# Access Compliance Report

## Public Rights-of-Way

### (Curb Ramps)

Intersection ID: 21105	Main Street: CHADWICK_PL	Cross Street: SHARON_VIEW_RD	Location: NW
ADA ID: 88B78E01E0E7	Ramp Type: BlendTrans1	Initial Pass/Fail: Fail	Overall Compliance: No
Severity Score: 8.75			
Codes/Mitigation Info/Possible Solution		Field Measurements/Component Compliance

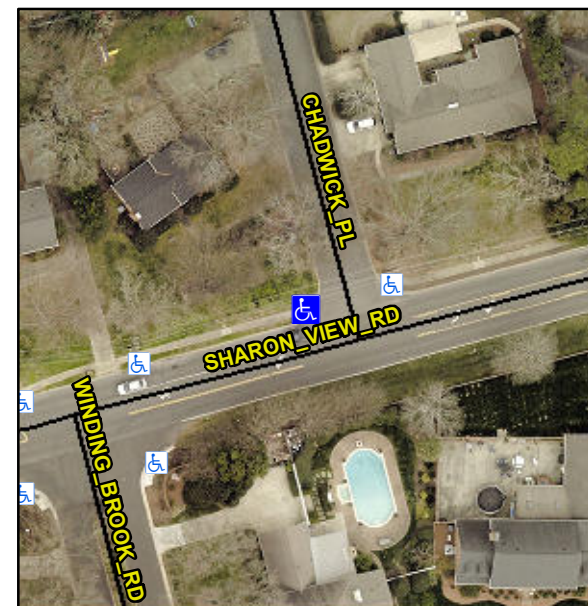
**Not Found, R304.5.1**

Compliance	Description	Data	Compliance	Description	Data
N/A	Ramp Length (in)	26.5	Yes	BlendTrans Slope (%)	3.1
No	Ramp Width (in)	39.0	Yes	BlendTrans XSlope (%)	0.6
N/A	Flare Type LT	N/A	N/A	Flare Type RT	N/A
N/A	Flare Slope LT (%)	N/A	N/A	Flare Slope RT (%)	N/A
N/A	Flare Traversable LT?	N/A	N/A	Flare Traversable RT?	N/A
N/A	Landing Length (in)	N/A	N/A	DWS Provided?	N/A
N/A	Landing Width (in)	N/A	N/A	DWS Contrast?	N/A
N/A	Landing Slope (%)	N/A	N/A	DWS Length (in)	N/A
N/A	Landing X Slope (%)	N/A	N/A	DWS Full Width?	N/A
N/A	Landing Curb? (Y/N)	N/A	N/A	DWS Offset (in)	N/A
N/A	Shared Landing?	N/A			
N/A	Gutter Ponding?	N/A	N/A	Gutter Slope (%)	N/A
N/A	Gutter Lip Ht (in)	N/A	N/A	Gutter X Slope (%)	N/A
N/A	Painted X Walk1?	No	N/A	Painted X Walk2?	No
	X Walk 1 Direction	To SE		X Walk 2 Direction	To NE
	X Walk 1 Width (in)	N/A		X Walk 2 Width (in)	N/A
	X Walk 1 Slope (%)	3.9		X Walk 2 Slope (%)	3.7
	X Walk 1 X Slope (%)	3.6		X Walk 2 X Slope (%)	5.8

N/A	Ramp inside XWalk1?	N/A	N/A	Ramp inside XWalk2?	N/A
	Road Slope (%)	3.3		Clear Space?	N/A
	Road X Slope (%)	3.7	N/A	Clear Space to XWalk (in)	N/A
N/A	Any Obstructions?	N/A	N/A	Storm Grate/Utility Hazard?	N/A
	Obstruction Type			Storm Grate/Utility Type	
		N/A			N/A
			Yes	Surface Condition? (G/P)	Good
			No	Curb Slope (%)	9.5

**Remove & Replace Curb Ramp With Two New Directional Ramps or Equivalent.**
